STAFF RECOMMENDATION
1501 Linden Avenue
July 21, 2021

Application: Demolition; New Construction—Outbuilding
District: Belmont-Hillsboro Neighborhood Conservation Zoning Overlay
Council District: 18
Base Zoning: R8
Map and Parcel Number: 10513008500
Applicant: Martin Wieck, Nine-12 Architects
Project Lead: Sean Alexander, sean.alexander@nashville.gov

NEW OUTBUILDINGS AT:
1501 LINDEN AVE.
NASHVILLE, TN 37212

1 ARCHITECTURAL SITE PLAN

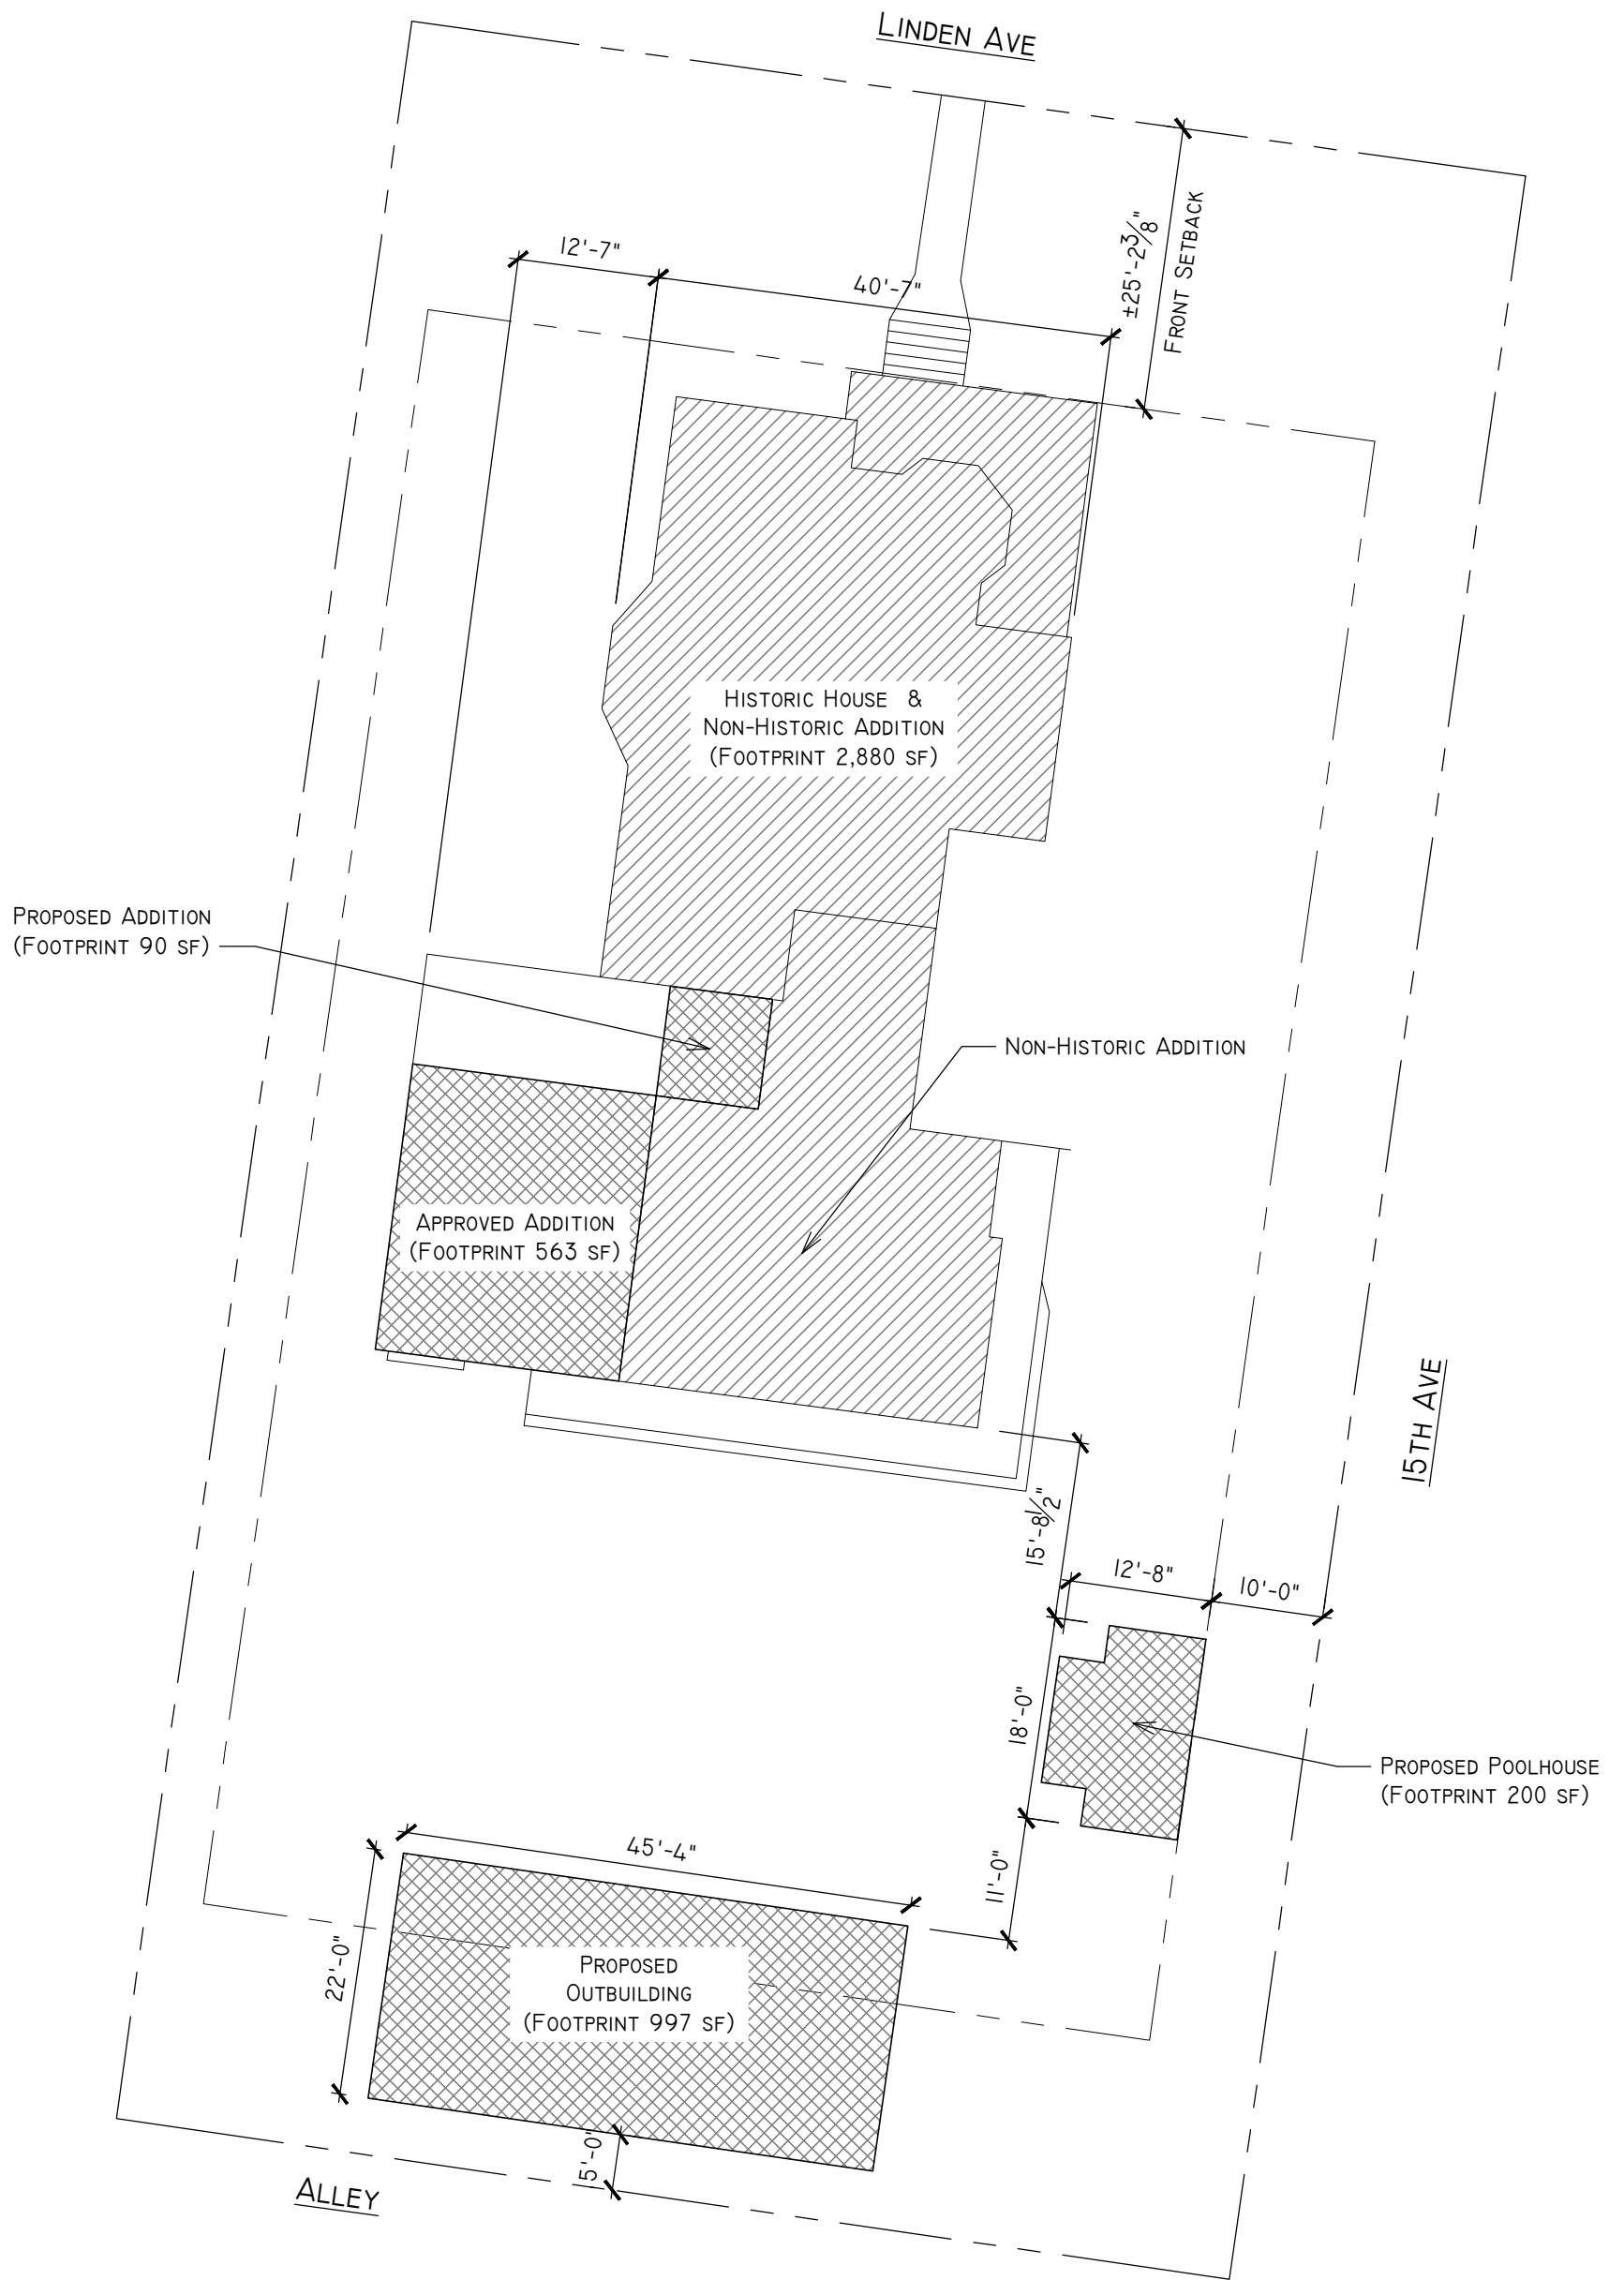
The outbuilding is proposed to be located in the rear yard, five feet (5') from the rear property line, more than five feet (5') from the interior side property line, and more than ten feet (10') from the street-facing property line.

Staff find the proposed outbuilding to meet section II.B.1.c. and II.B.1.i.2 of the design guidelines.

EXTERIOR ELEVATIONS
 03

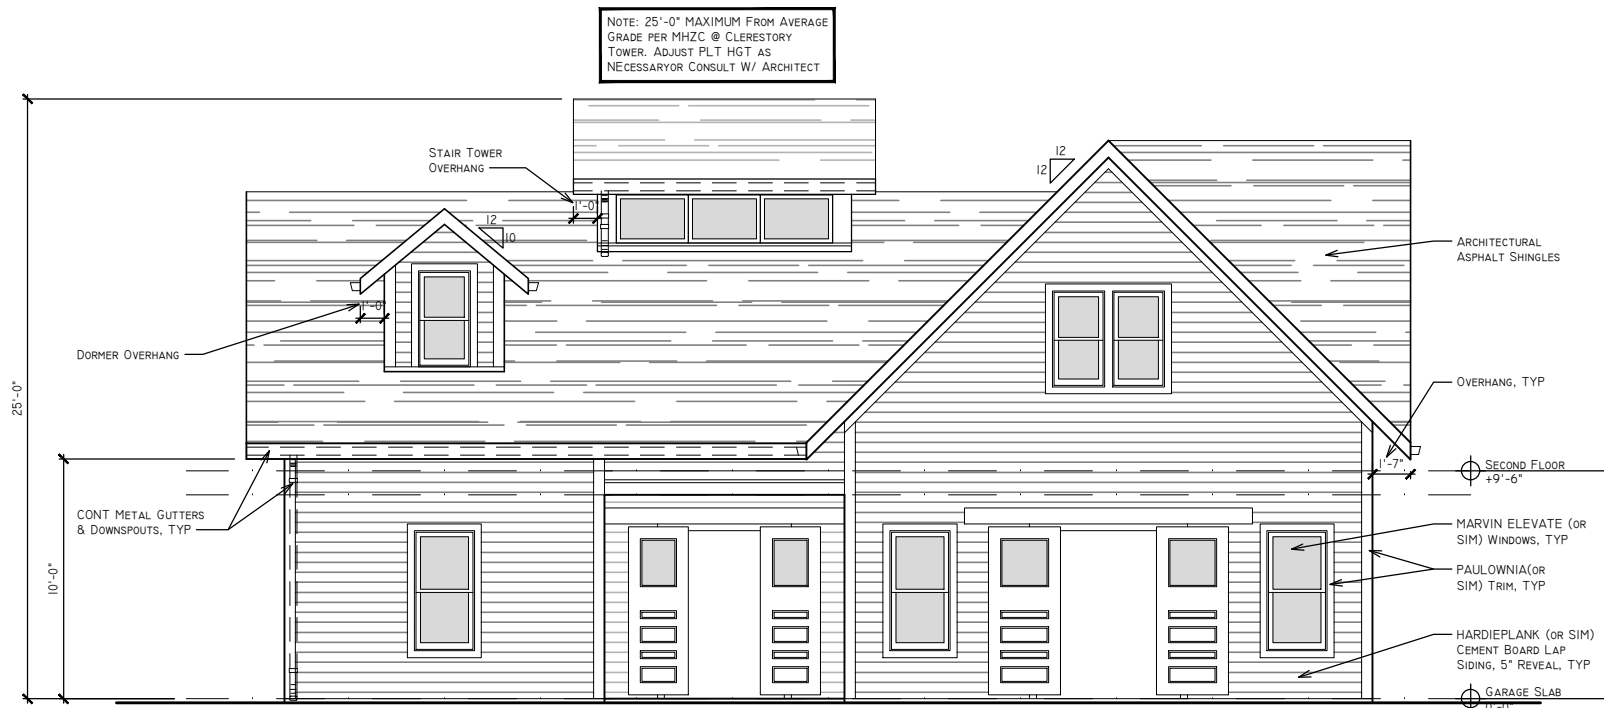
A “clerestory tower” or cupola will sit on the primary side-to-side roof ridge of the structure. The roof of this feature will be gabled with a pitch of 10/12. This type of feature is not typical of surrounding historic outbuildings and will be highly visible since this is a corner lot.

With a condition that the tower or cupola element is removed, Staff finds that the proposal meets sections II.B.1.e. and II.B.1.i. of the design guidelines for outbuildings and roof form.

With the exception of the tower or cupola element described above, the proposed structure has a simple form that is compatible with historic outbuildings. The building will include a two-bay garage door and a single-bay door on the South elevation. The Commission typically requires single-bay garage doors, but Staff finds the two-bay door to be appropriate because it faces the alley.

1. The tower or cupola element shall be eliminated; and
2. Staff shall approve the window and door selections prior to purchase and installation.

EXTERIOR ELEVATIONS

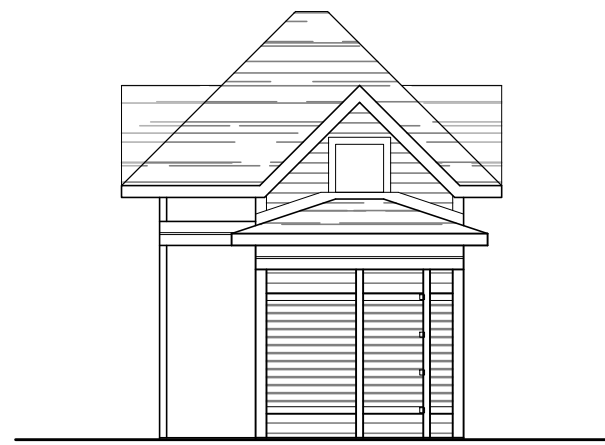
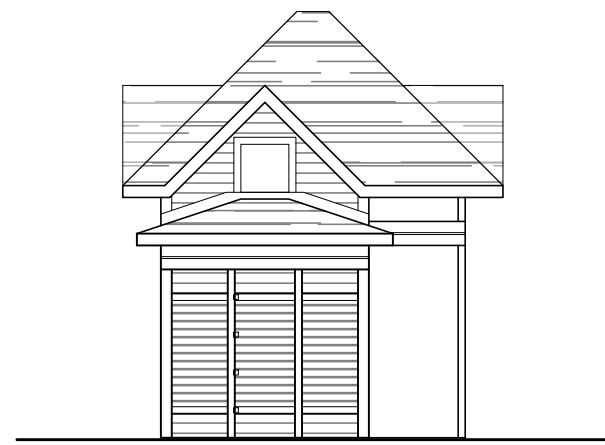
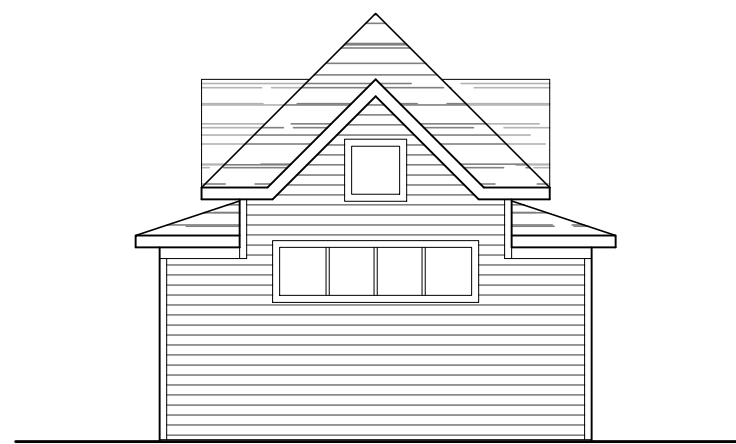
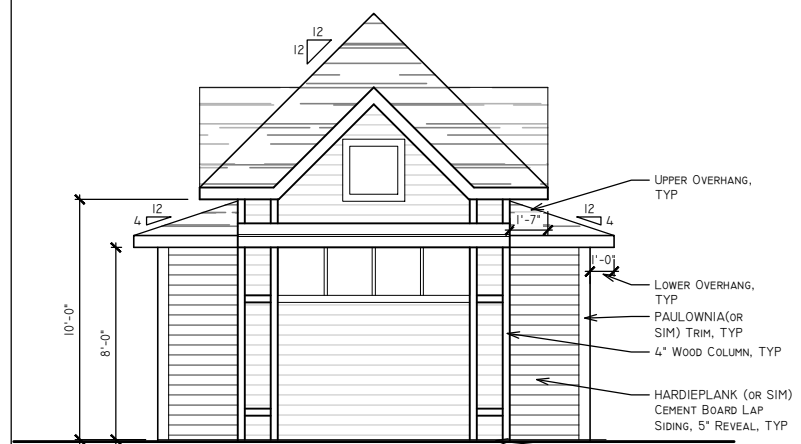
The proposed pool house will have a character similar to the larger outbuilding and the primary building, with matching materials and a hipped roof with a matching 12/12 pitch.

Staff finds the location, form, and materials of the poolhouse to be appropriate and to meet section II.B.1.c. and II.B.1.i.2 of the design guidelines.
